| | | STANDARD DESIGN - 40' ROADWAY, THREE SPAN BRIDGE PRETENSIONED PRESTRESSED CONCRETE BEAM BRIDGES AUGUST, 2009 | |
| | | WING ARMORING DETAILS A & B BEAMS | H40-90-06 |

TOP VIEW OF WING ARMORING

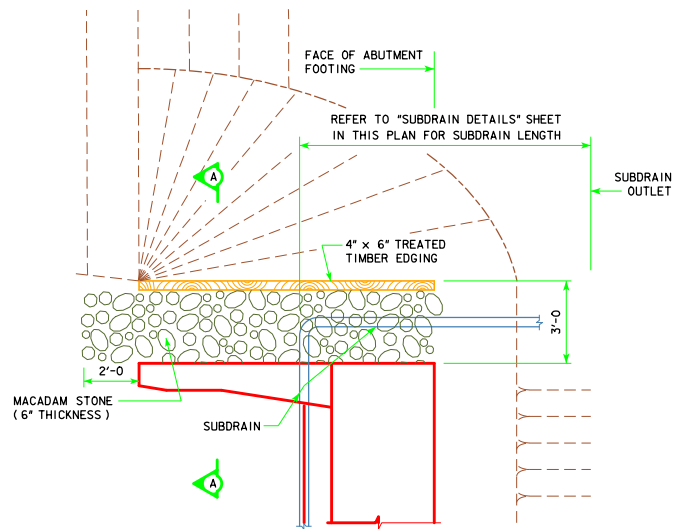
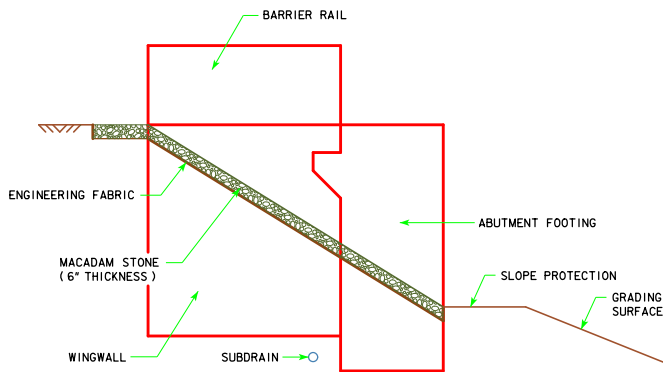
REVISED 09-14 - CHANGED THE AREA OF THE MACADAM STONE AREA TO 2'-0" IN FRONT OF THE BRIDGE WING.
